Project:	Lower Berse Farm, Ruthin Road, Wrexham	Scheme No:	13840
Subject:	Response to LLFA Comments	Revision:	01
Client:	Redrow Homes Ltd	Date:	23/06/2026
Doc Ref:	13840-Response to LLFA Comments - 03		
Author:	Aled Williams BSc (Hons) MCIWEM C.WEM

Waterco have received additional comments dated 1st May 2026 from Pell Frischmann acting as Lead Local Flood Authority (LLFA) for Wrexham County Borough Council in relation to an outline planning application (P2024/1466) for 1450 dwellings and provision of land for a Primary School at Lower Berse Farm, Ruthin Road, Wrexham, LL14 4HP.

Project	Lower Berse Farm
Document Title	P/2023/0593 - Lower Berse Farm Planning Response.
Document Reference	P_2023_593-PEF-HDG-XX-TN-D-0001
Revision Reference	P02
Date	01/05//26

TECHNICAL NOTE – FLOOD RISK & DRAINAGE COMMENTS

Figure 1 – Parcel A - 1% AEP plus 45% CC Event – Water Level Mapping

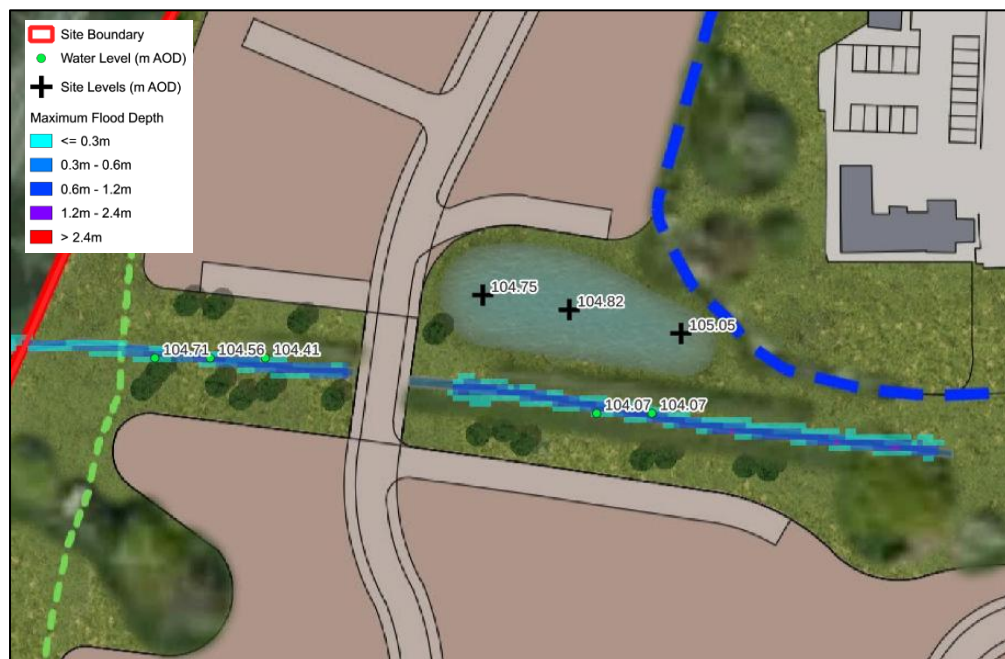
- 1) Clarification on areas used for calculation of greenfield runoff rates.
- 2) Clarification of climate change allowances used (40% vs 45%).
- 3) For Parcel A (north-eastern extent of the site), a contour/heat map type drawing is required showing the interaction between the attenuation pond perimeter/footprint and the 93.89m AOD flood level.

- Please provide a contour/heat map type drawing showing the interaction between the pond perimeter/footprint and the 93.89m level/contour.

- 3) A plan showing maximum water levels during the 1% Annual Exceedance Probability (AEP) plus 45% climate change event overlaid onto the site layout is included in Appendix B and also as Figure 1. As shown in Figure 1, the pond serving Parcel A will be placed on ground above the 1% AEP plus 45% CC flood level of 93.89m AOD (the mapping in Appendix B shows flood levels rounded to 93.9m AOD).

PLOT TITLE: MAXIMUM WATER LEVEL
1% AEP PLUS 45% CLIMATE CHANGE FLUVIAL EVENT
PROPOSED DEVELOPMENT SCENARIO (DEV)
NORMAL FLOW CONDITIONS (NC)
PARCEL H

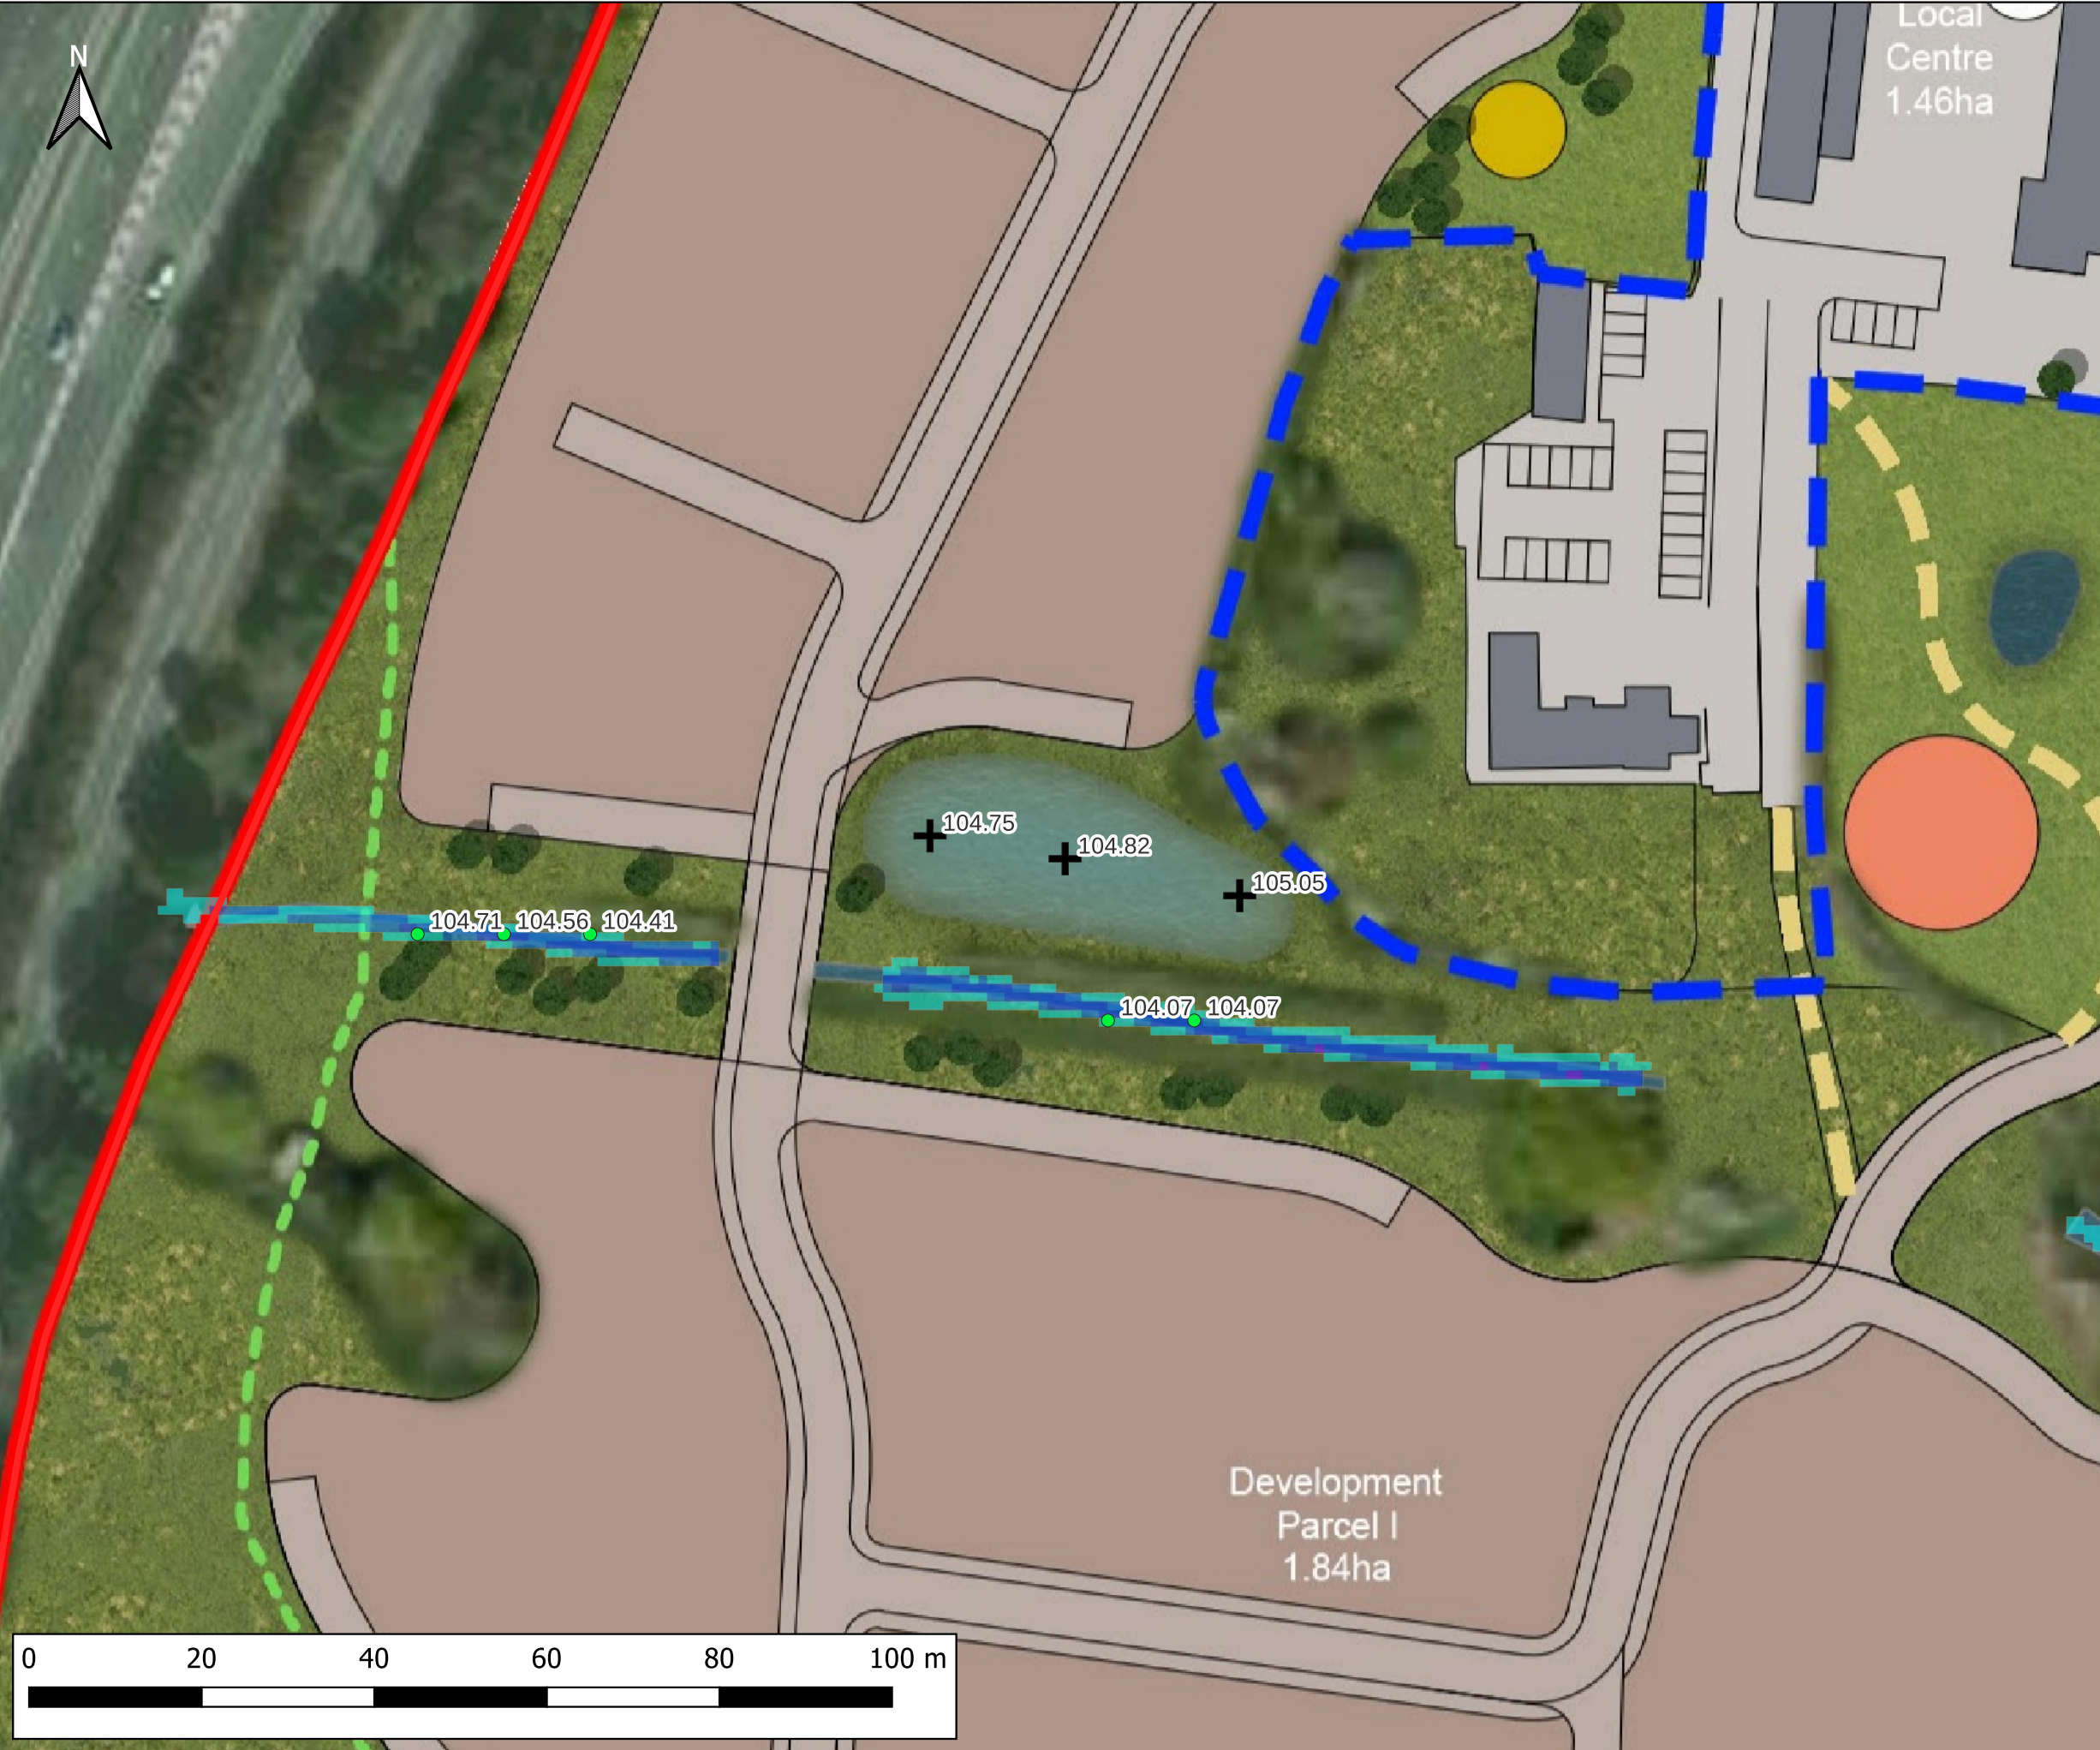
- 4) For Parcel H (north-western extent of the site), a contour/heat map type drawing is required showing the interaction between the attenuation pond perimeter/footprint and the watercourse, showing that the flood extent does not impact upon the pond.

- Northwest pond – noted on relative levels, please provide a contour/heat map type drawing with levels/contours on relative to the pond perimeter/footprint and the watercourse. We need to see the impact of the pond on the flood zone in greater detail than the flood model mapping. A cursory view appears to show the pond in/partly in Zone C2. Actual site levels may show this be untrue, hence this request.

- 4) As shown in Figure 2, the pond serving Parcel H will be placed on ground above the 1% AEP plus 45% CC flood level of 104.07m AOD. No out of channel flooding is estimated in this location.

Appendix C – Digital Elevation Models

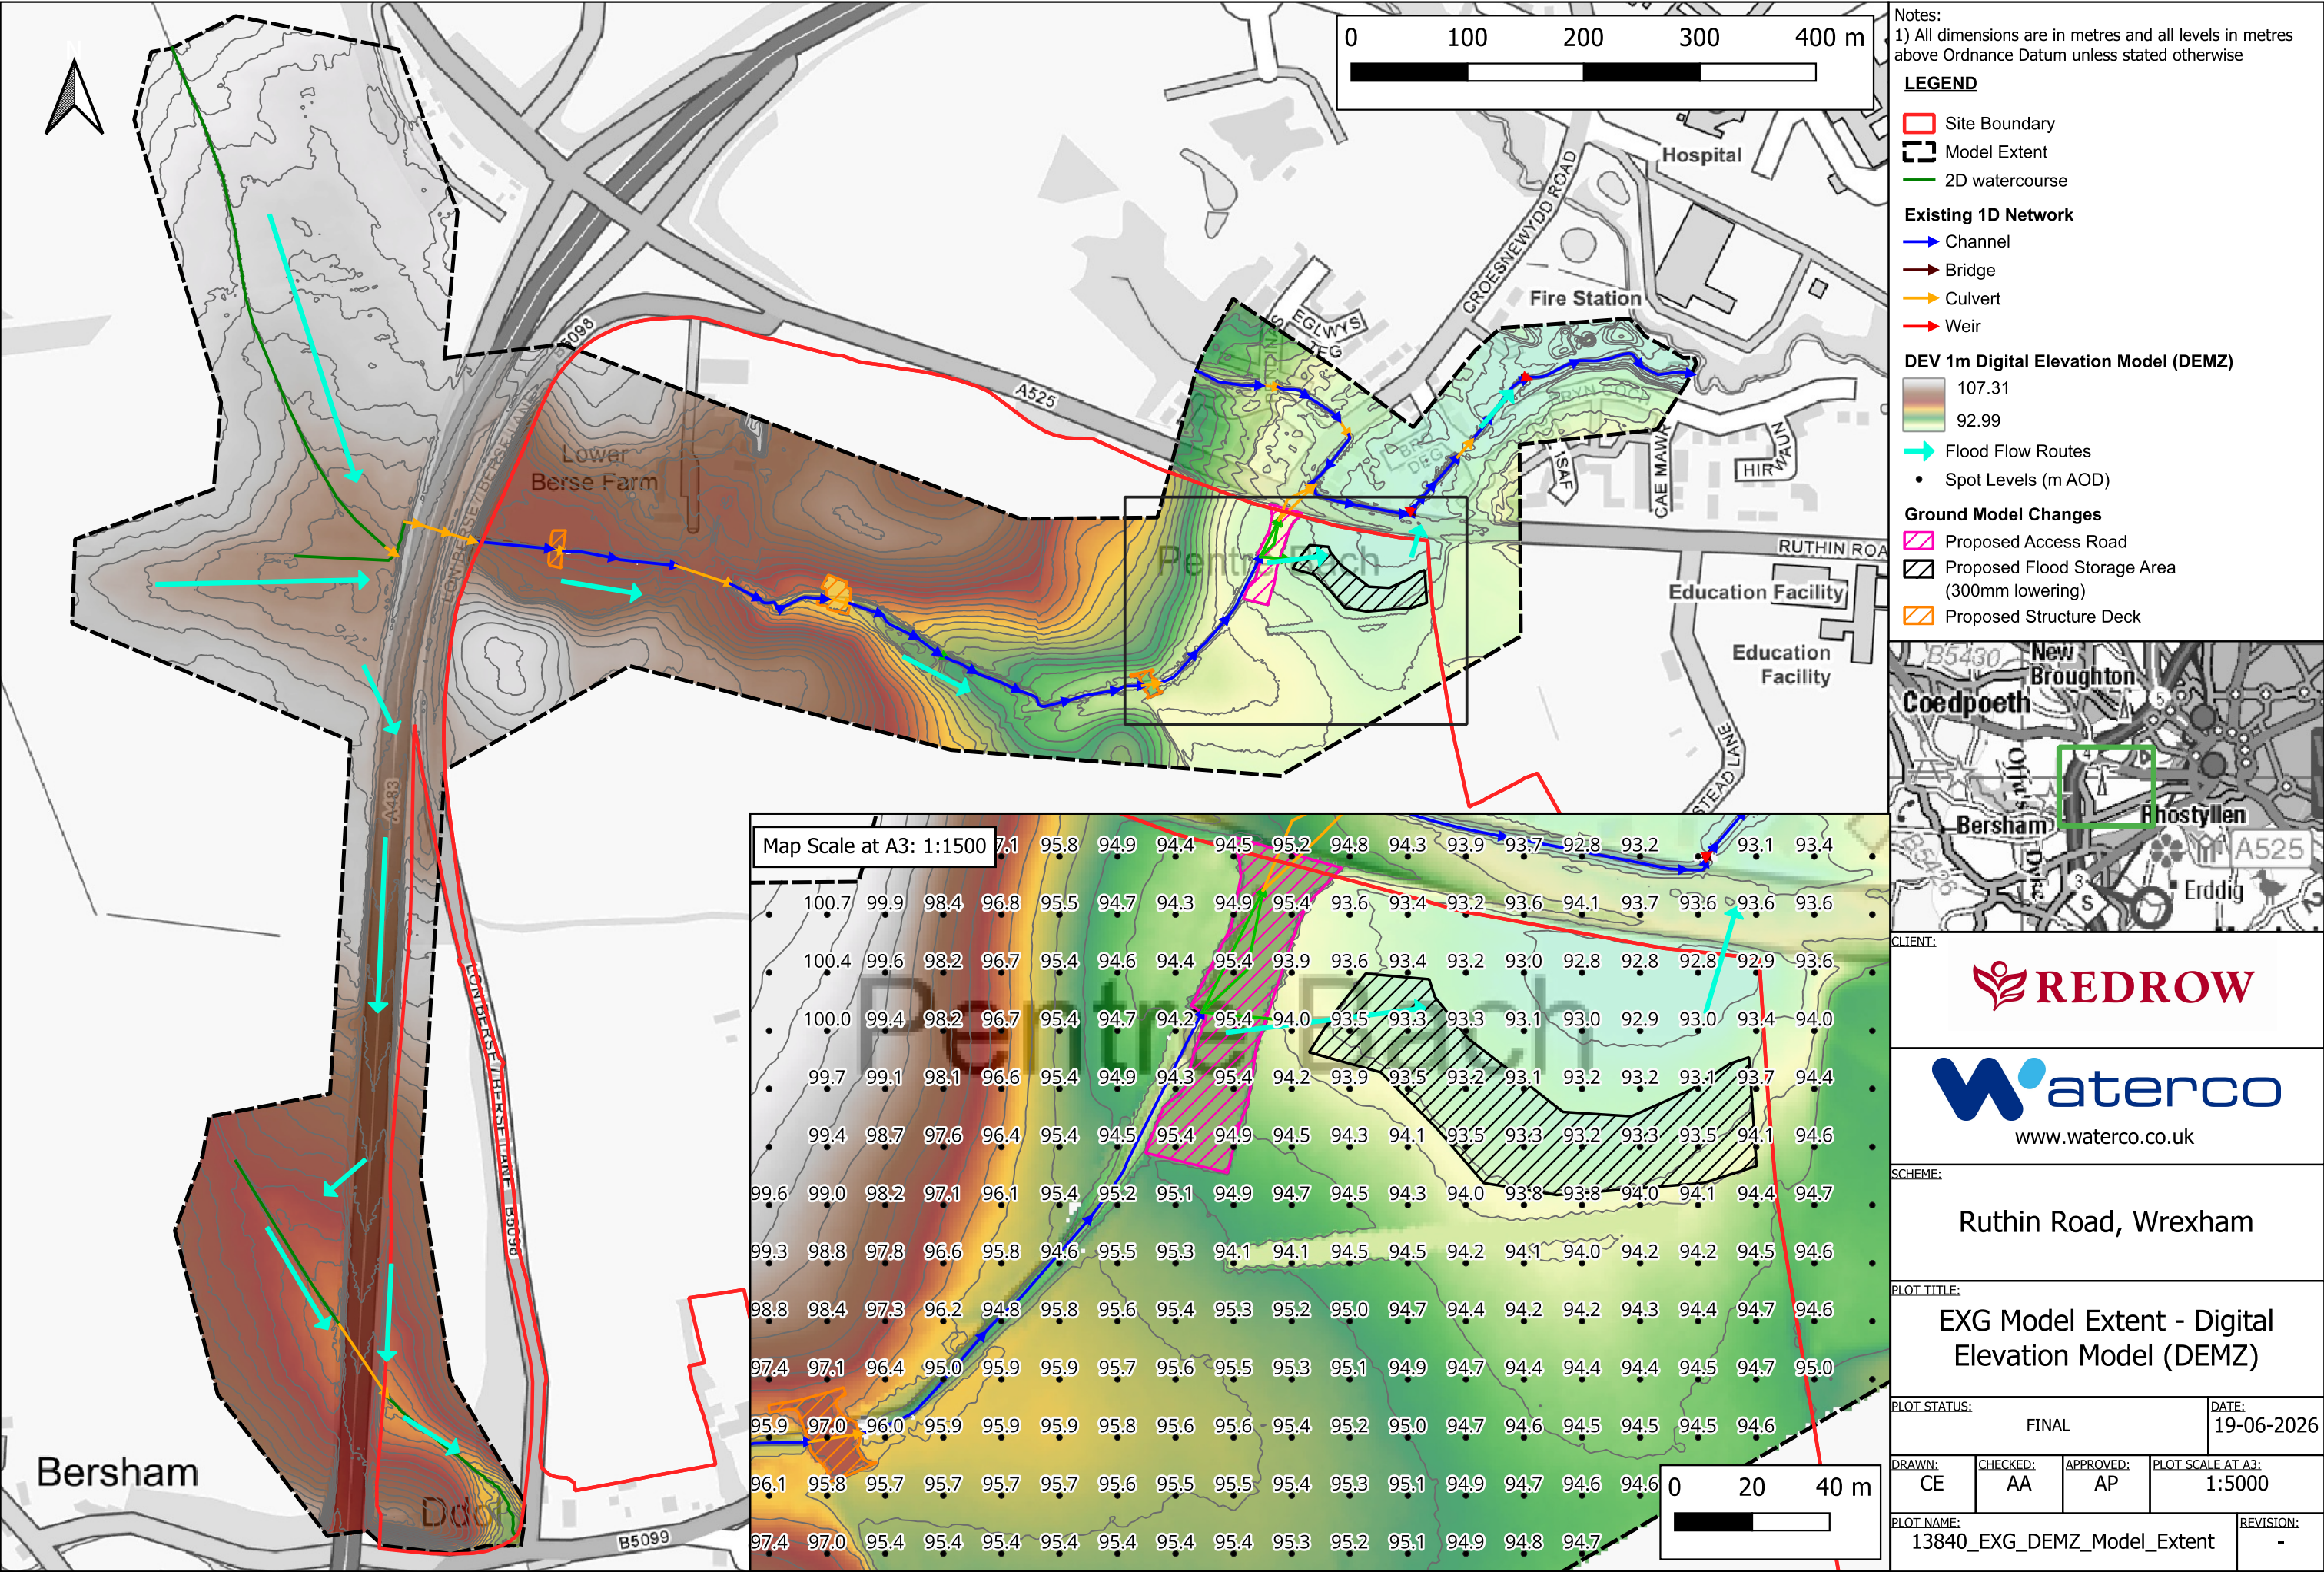
- The flood maps are an important pointer on viability, but we require some more detail as follows:
 - Provide the requested levels/volume information in the form of a contoured and flow route plan (proving connectivity to the watercourse to allow exceedance runoff to reach the flood storage area). Please provide this for the existing and proposed situation, based on topographic levels and proposed levels/surfaces respectively. Please also provide a comparison surface model.

- Undertake a similar exercise for the new access road/junction area.
 - The above two requests can be combined into one piece of work/model.
 - We are not expecting final/detailed design, but we do require levels/contours models to be developed enough for us to be satisfied that flood risk in this part of the site will not be increased because of the development.

- 5) Existing and proposed Digital Elevation Models are included as Appendix C and show the change in elevation in the location of the flood storage area and north-eastern access road. Flood flow routes are also provided on the Digital Elevation Models. The flood storage area is existing, and modifications include lowering higher ground towards the southern extent of the flood storage area by 300mm to create additional storage capacity.
